LHC Beam Dump System (LBDS)

Report on the Audit held in January/February 2008

The LHC Beam Dump System

Report on the Audit held on January 28th to February 15th 2008

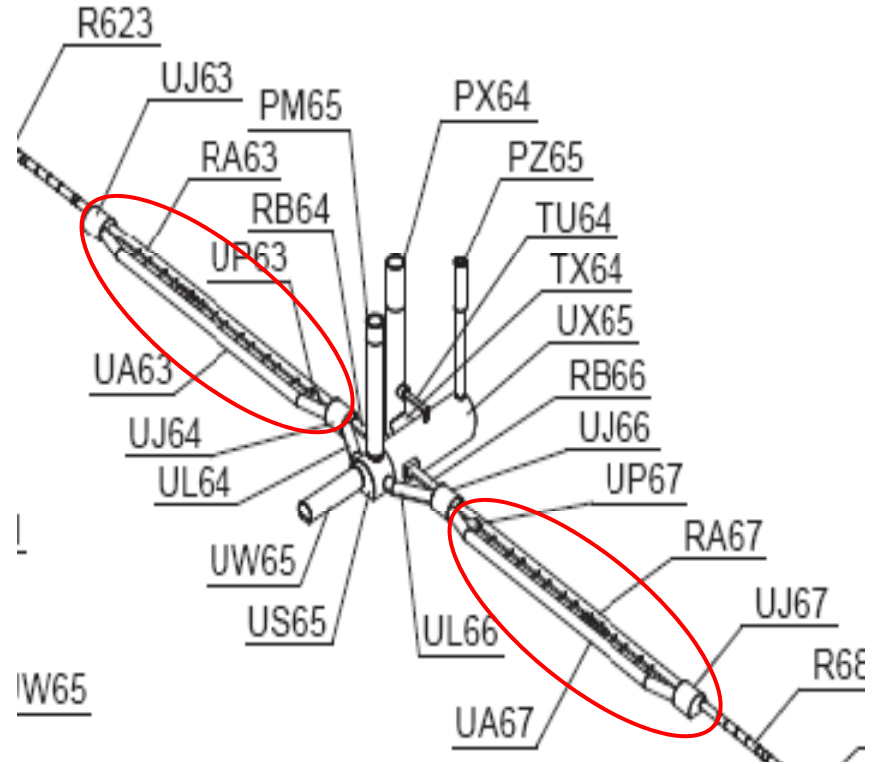
Magnet assemblies account for about 99.5% of the un-safety, while the trigger electronics covers the remaining 0.5%:

- 14. Since the focus of this review was on the trigger electronics, an independent review of the high power system components should be organised.

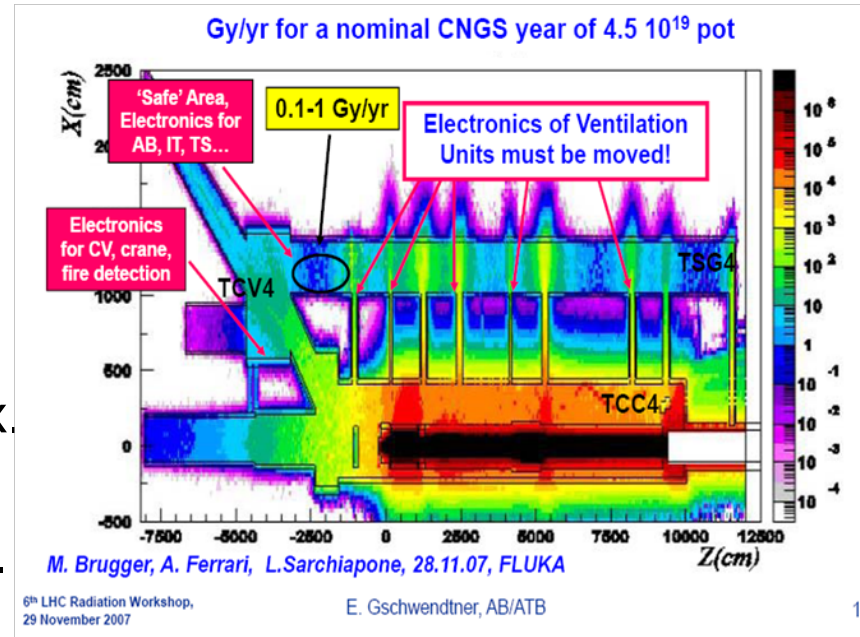
LBDS hardware installed in-line with cable ducts to kicker magnets:

- Radiation-tolerance not part of design
- SEEs in CMOS & FPGA hardware, VHDL & PLC code, look-up-tables...

22. Quantify risks due to SEEs & “aging”.

23. Simulations to determine expected flux.

24. Create list of susceptible components (e.g. CMOS on the critical signal path).

25. Together with SEE expert, perform irradiation experiments to identify failure modes and cross-sections.

26. Contact Xilinx FAE in order to quantify the risks of FPGA mal-function with the given flux.
